<b>Southern California Edison Company</b>  <b>INTERIM CALCULATION CHANGE NOTICE (ICCN)/ CALCULATION CHANGE NOTICE (CCN)</b>	CALC NO. C-259-1.01.11	ICCN NO./ PRELIM. CCN NO. <b>N-3</b>	PAGE <b>1</b>	TOTAL NO. OF PAGES <b>44</b>
	BASE CALC. REV. <b>2</b>	UNIT <b>2 &amp; 3</b>	CCN CONVERSION: CCN NO. <b>4</b>	CALC. REV. <b>2</b>
	CALCULATION SUBJECT: Evaluation of Spent Fuel Pool for Westinghouse High Density Racks			
CALCULATION CROSS-INDEX <input checked="" type="checkbox"/> New/Updated Index Included <input type="checkbox"/> Existing Index is Complete	ENGINEERING SYSTEM NUMBER/PRIMARY STATION SYSTEM DESIGNATOR <b>2202 / XE1</b>		Q-CLASS <b>II</b>	
<b>1. BRIEF DESCRIPTION OF ICCN/CCN:</b>	CONTROLLED PROGRAM OR DATABASE IN ACCORDANCE WITH NES&L 41-5-1 <input type="checkbox"/> PROGRAM <input type="checkbox"/> DATABASE	PROGRAM/DATABASE NAME(S) <input type="checkbox"/> ALSO, LISTED BELOW <b>N/A</b>	VERSION/RELEASE NO.(S)

<p>During the refueling outage for cycle 8, the Control Element Assemblies (CEAs) will be removed from the reactor and replaced with new CEAs. The old CEAs will remain within the spent fuel pool for storage. The top of the CEA will be closer to the top of the storage r

Sheet No. 292 M

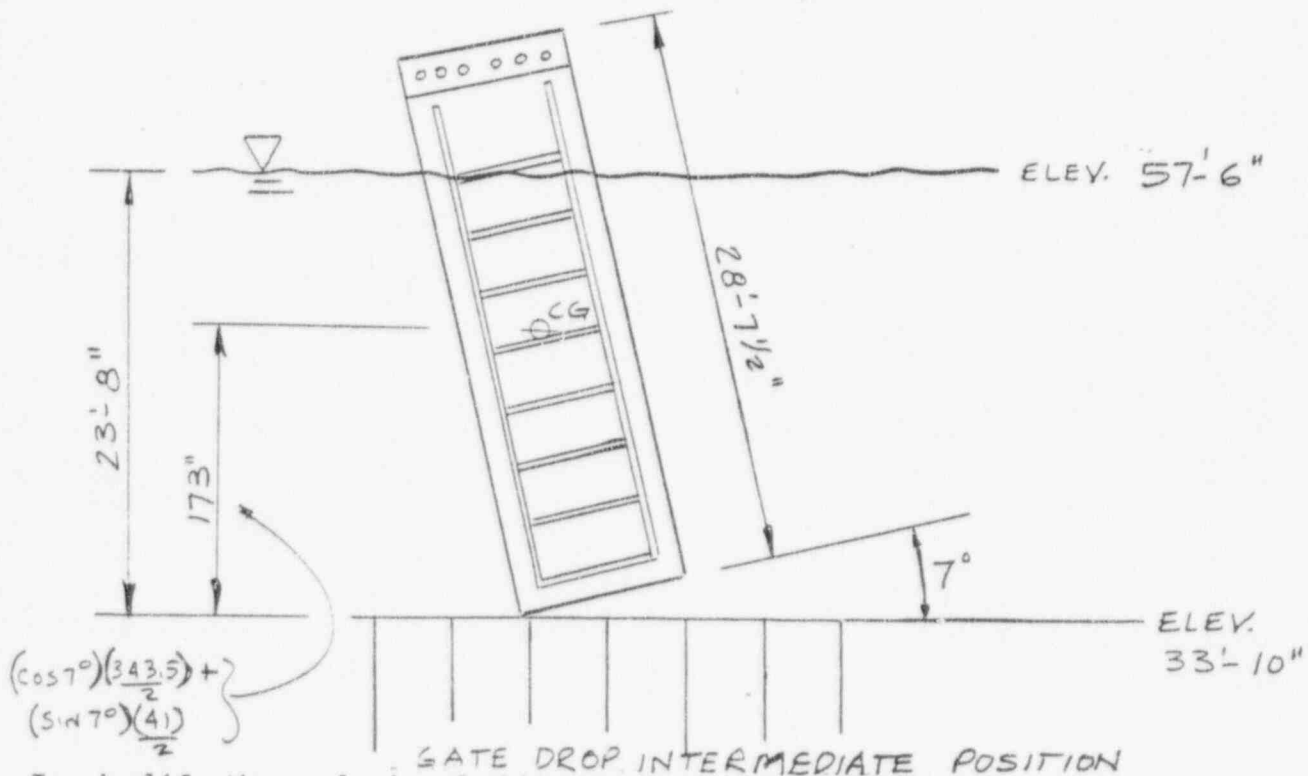
The sketch below provides the dimensions of concern to describe the secondary gate drop.

Note: The gate position shown below is subsequent to initial impact and prior to toppling. The initial penetration into the rack is neglected here providing a greater center of gravity height.

To simplify the analysis of this accident, the following conservative assumptions will be used as a basis for the model shown in the sketch below.

- The gate is in a horizontal position prior to its drop, and remains in this position throughout its entire drop duration.
- The gate is initially located with the top just below the surface of the water. This position is conservative, since it raises the gate's center of gravity much higher than the initial position subsequent to the initial impact previously postulated.
- The only drag to be considered will be for the front (leading) surface of the gate. The drag on the trailing lip (which would be nearly equal to the leading surface) and the skin friction will be neglected.

GATE DROP MODEL

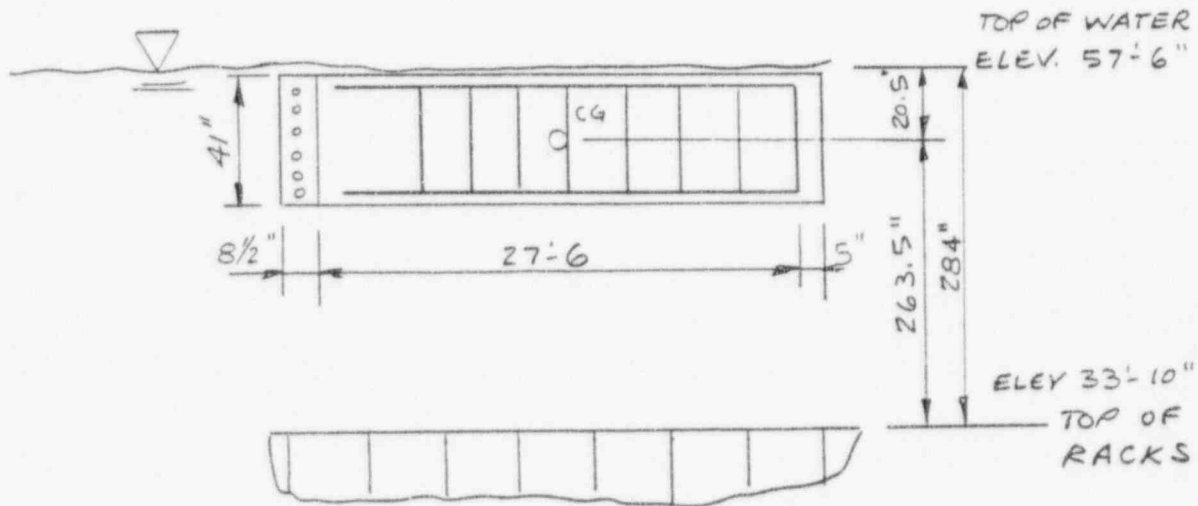
The sketch below shows the initial and final position of the gate as modeled and considering the assumptions stated above for the postulated secondary drop. This model will be conservative for the actual gate drop configuration. The elevation of the top of the racks will be taken to be 33'-10". This elevation is lower than the actual elevation, which is conservative, since the greater the drop distance is, the higher the kinetic energy will be.

The methodology outlined in BC-TOP-9A [10], and previously used on sheets 288 through 292A, will be used to determine the impact velocity and kinetic energy of the gate. The weight of the gate will be taken as 4,650 lbs, as determined on sheet 292G, considering the rigging and load block.

The coefficient of drag ( $C_D$ ) is 1.27, also given on sheet 288. This value is conservative due to the greater cross sectional area of the side of the gate compared to the bottom of the gate.
